MCTC-41

Change Notification

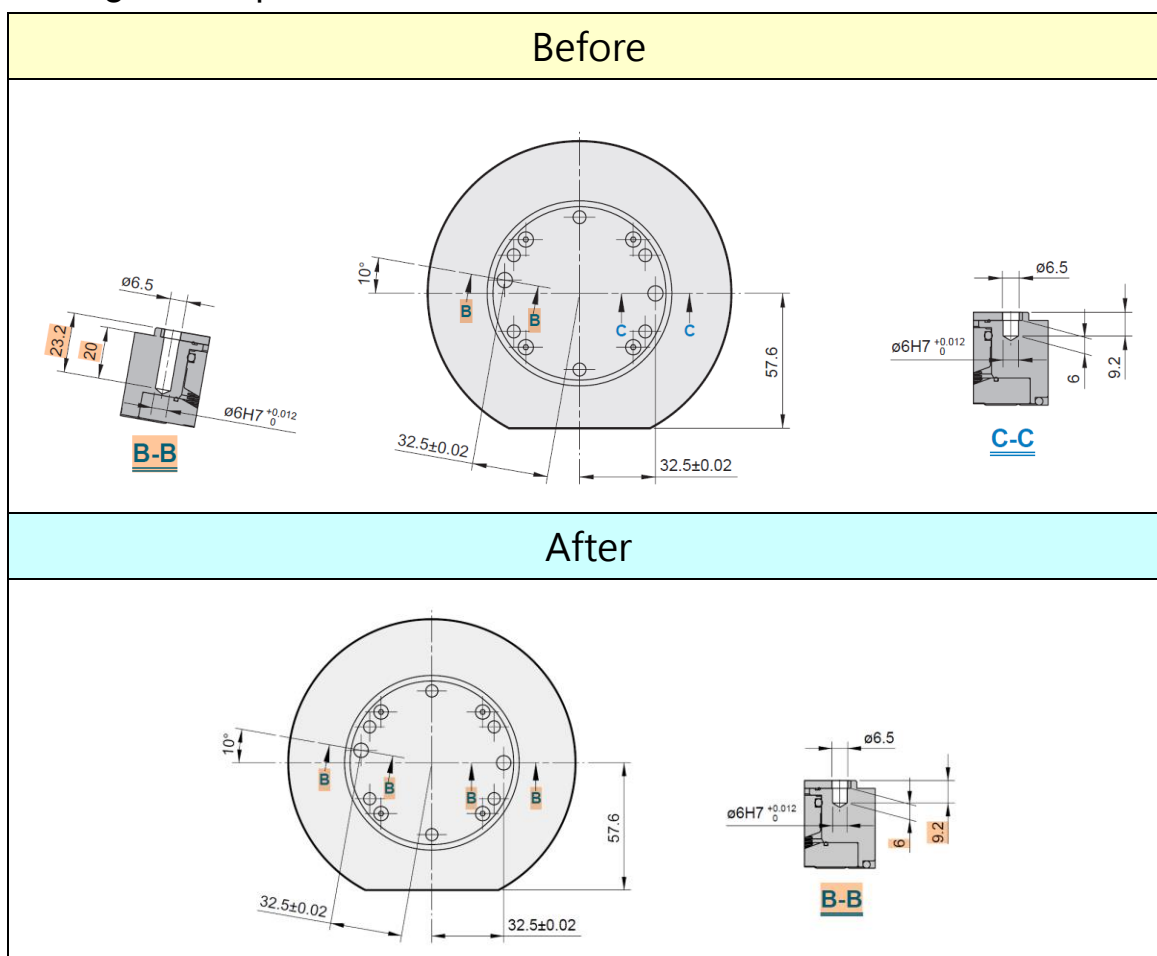
1. Model series
MCTC-41
2. Design change reason
Correct the depth of the locating hole at the base plate(R).
3. Change descriptions
